SKYWAYS TECHNICS	ASSESSMENT REPORT	SWT WO	003171	REV	00
		CUST PO	RMN-22-392	DATE	1-JUNE 2022

PART NUMBER	355A81-1030-100	DESCRIPTION	RADOME
SERIAL NUMBER	N/A	REMOVED FROM A/C REG	N/A
CUSTOMER	GALAXY AEROSPACE (M) SDN. BHD.

FIGURE 1

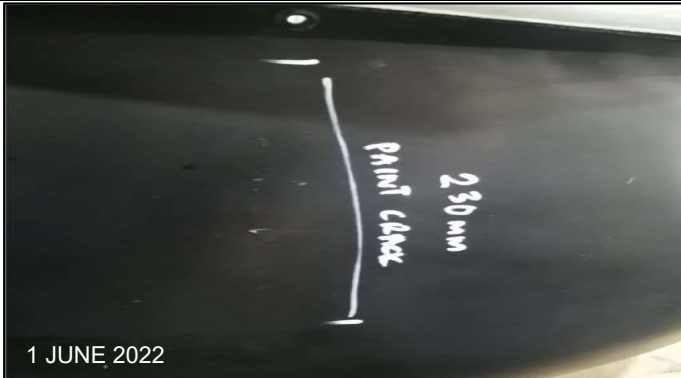
- Visual inspection carried out found paint crack on outer space with length 230 mm.

- Unit to be painted as per Standard Practices Manual 20-04-05-413.
